# Sydney Metro West Westmead to The Bays and Sydney CBD

Amendment Report  
Concept and Stage 1  
2020

Figure 6-11: Estimated groundwater level drawdown from the current water level after two years due to Stage 1 excavation at The Bays Station construction site for the amended station box footprint

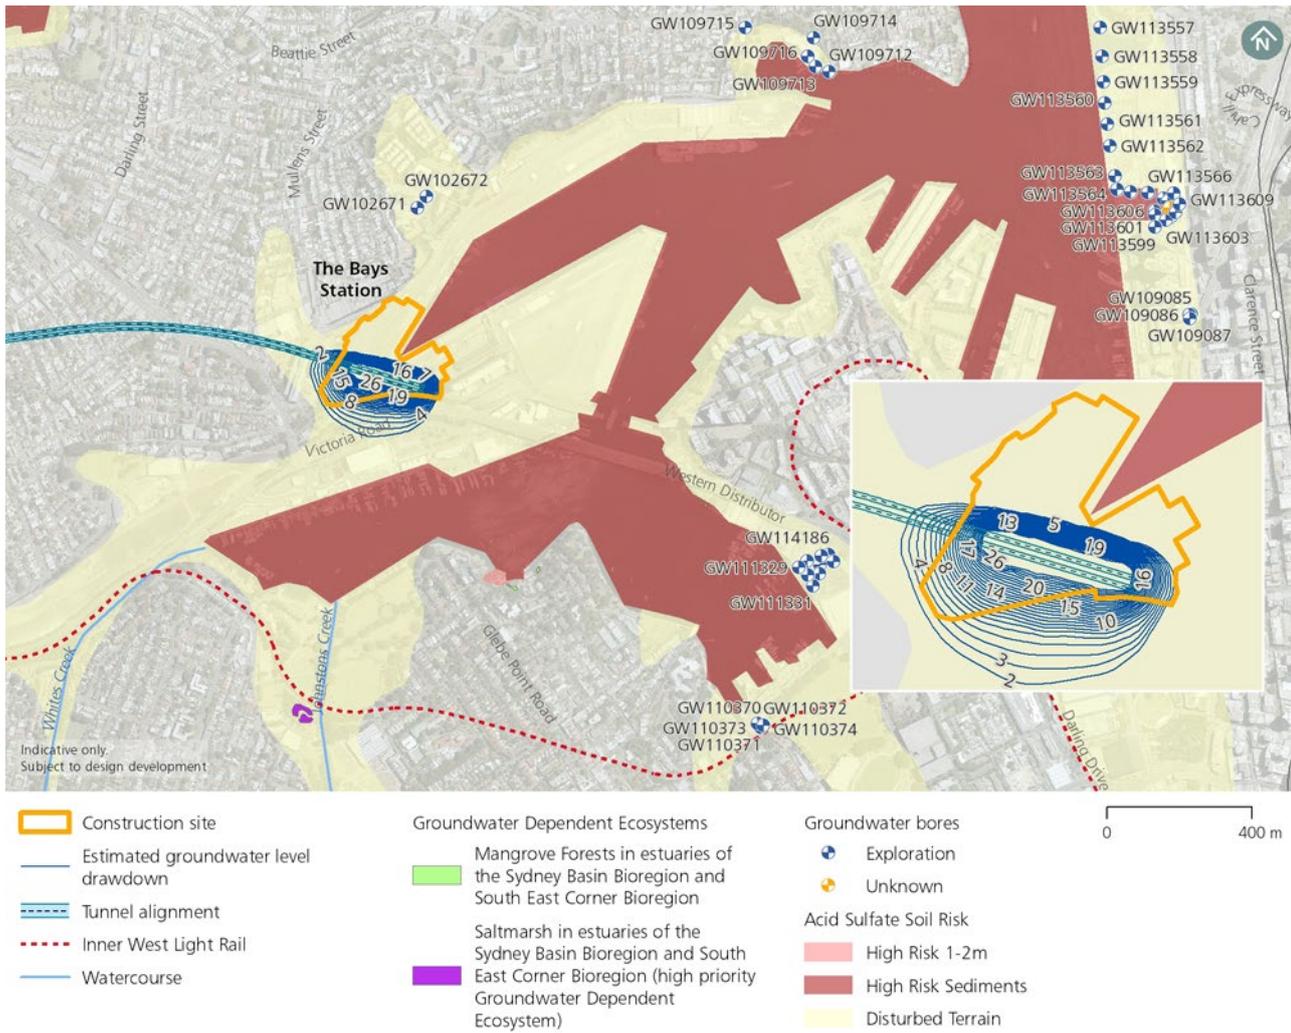
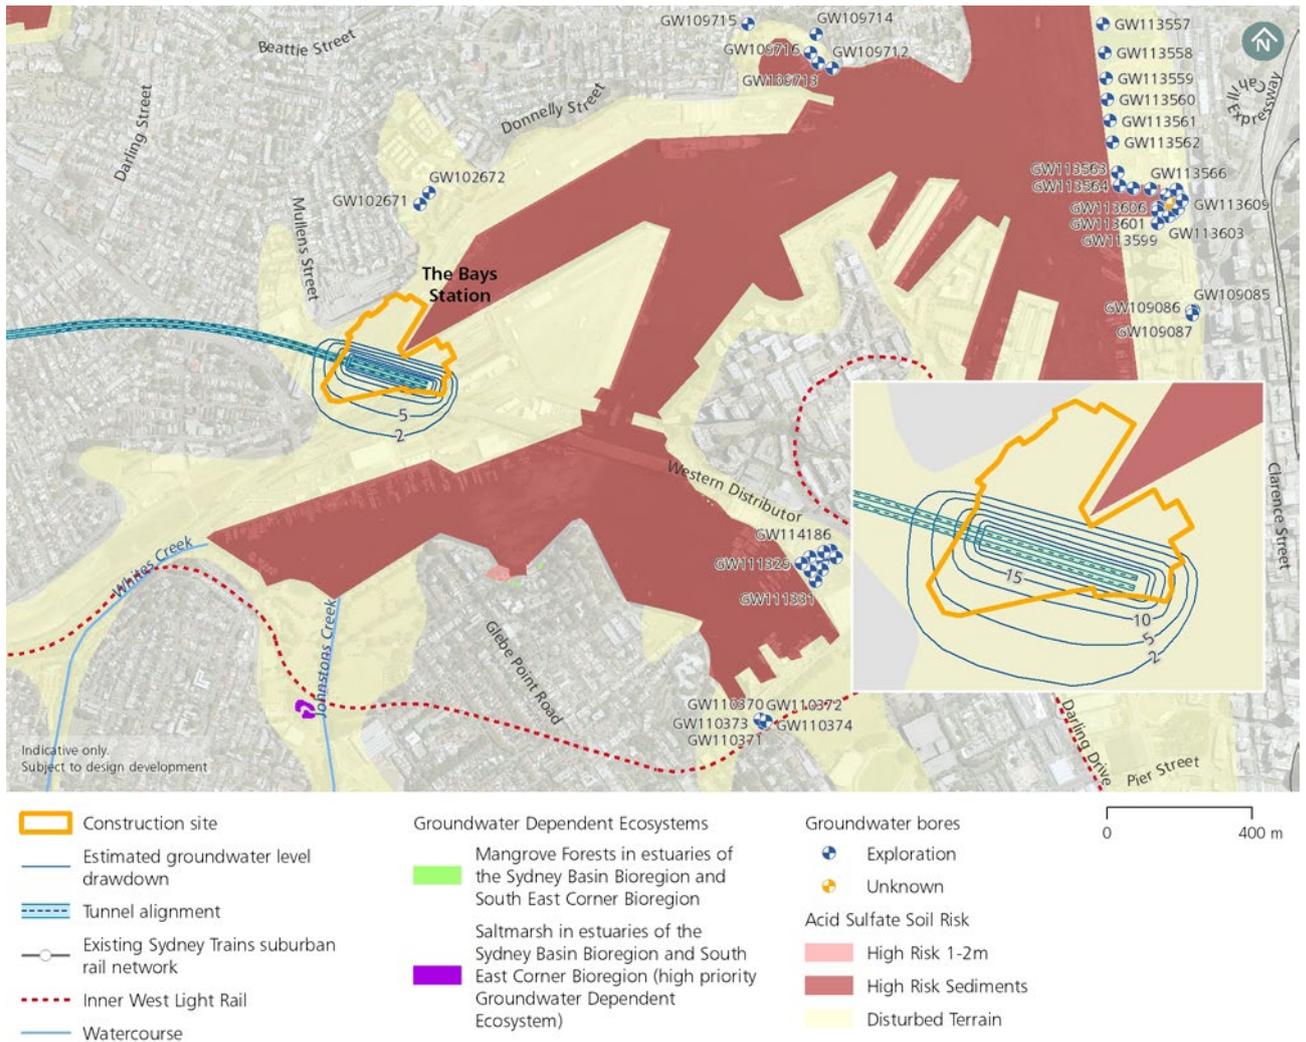
Potential changes in groundwater impacts due to these proposed amendments would be negligible from those described in the Environmental Impact Statement. Figure 6-10 shows the predicted groundwater level drawdown at The Bays Station construction site, as reported in the Environmental Impact Statement, and Figure 6-11 shows the predicted groundwater level drawdown at The Bays Station construction site for the amended station box footprint/excavation.

Figure 7-2: Proposed amended power supply works for The Bays Station

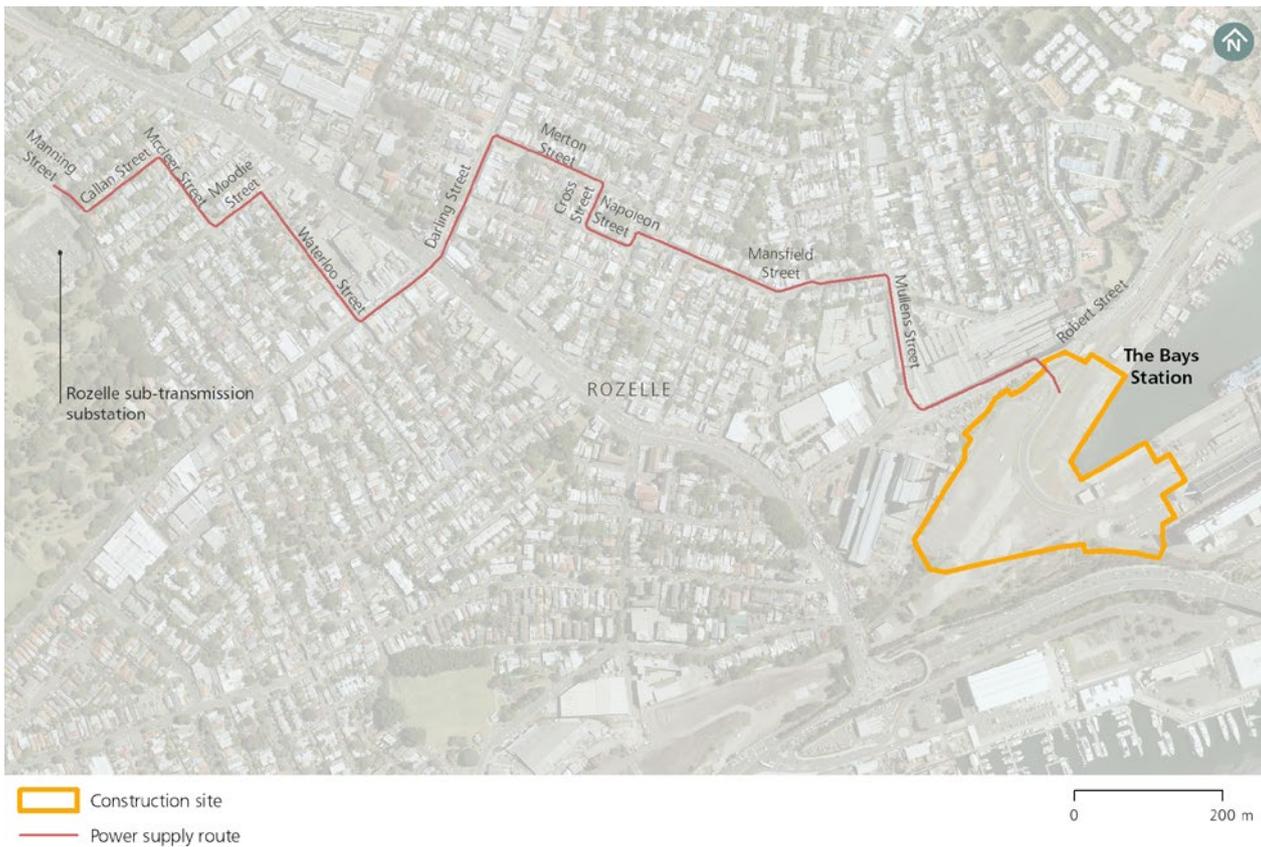
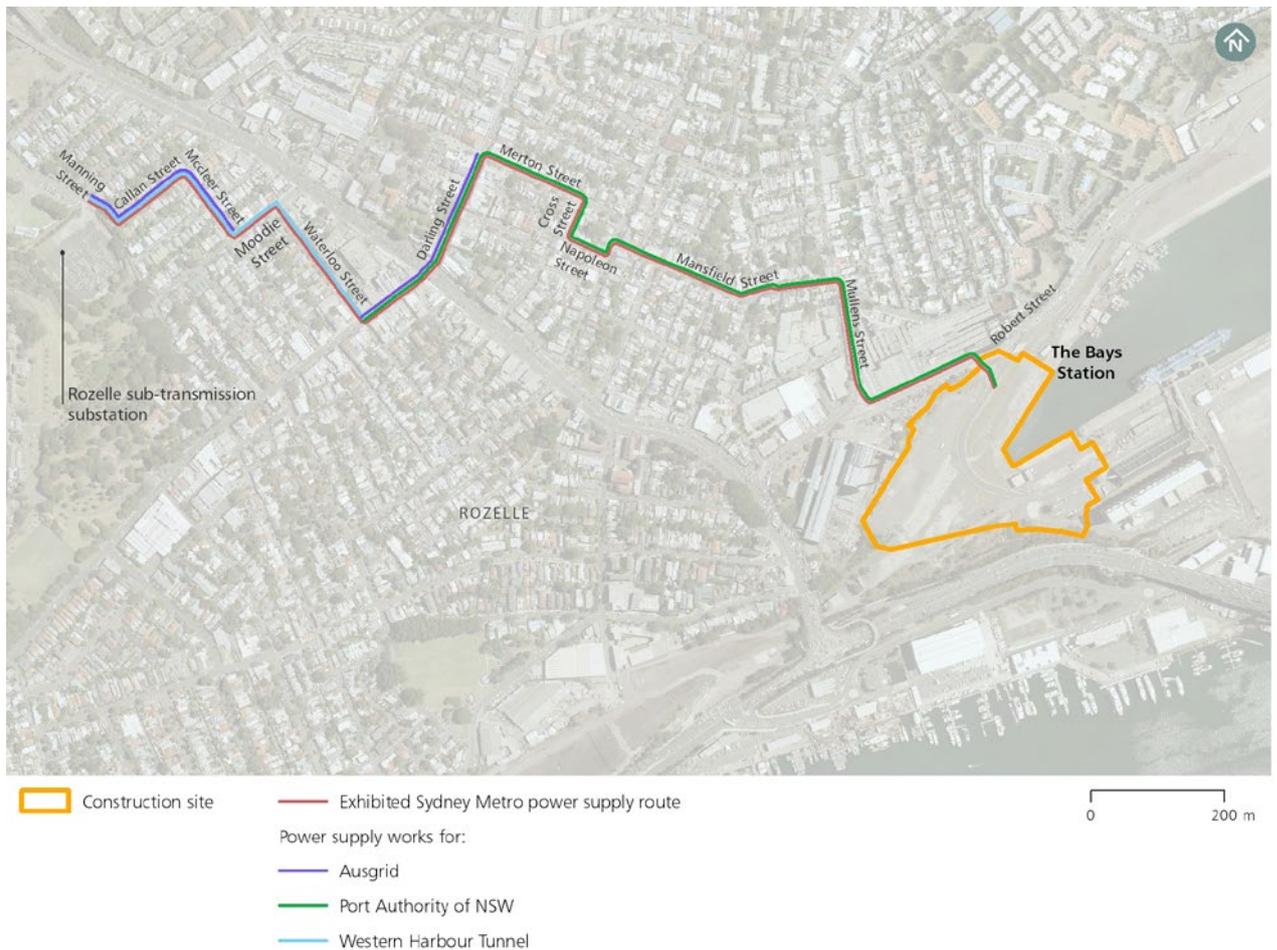
The power supply route is consistent with the route shown in the Environmental Impact Statement. The locations along the power supply route where Sydney Metro would undertake additional work are identified in Figure 7-2.
